Mount Munro Section 92 Response to Items 96 - 109

The purpose of this letter is to provide responses to the Section 92 additional information request for items 96 – 109, received by Meridian Energy Limited (Meridian) in response to their Resource Consent application for a new Wind Farm at Mount Munro.

Figure 2.1: Road R01 Corridor Width

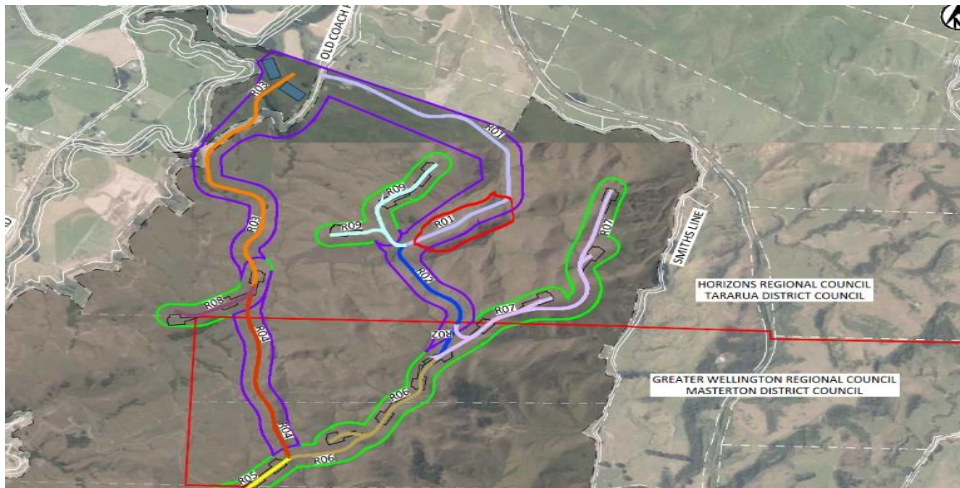
What geotechnical aspects have influenced the wider corridor width in roading zone section R01?

Where R01 crosses the stream and heads upslope in a south westerly direction (see red circled area in Figure 2.1), the corridor width is driven by the maximum preferred road gradient and also potential slope instability on the eastern slopes above the proposed R01 road. A wider corridor in this area will allow for shallower batter slope angles where slope instability is encountered or is expected to occur and no stabilisation measures are constructed.
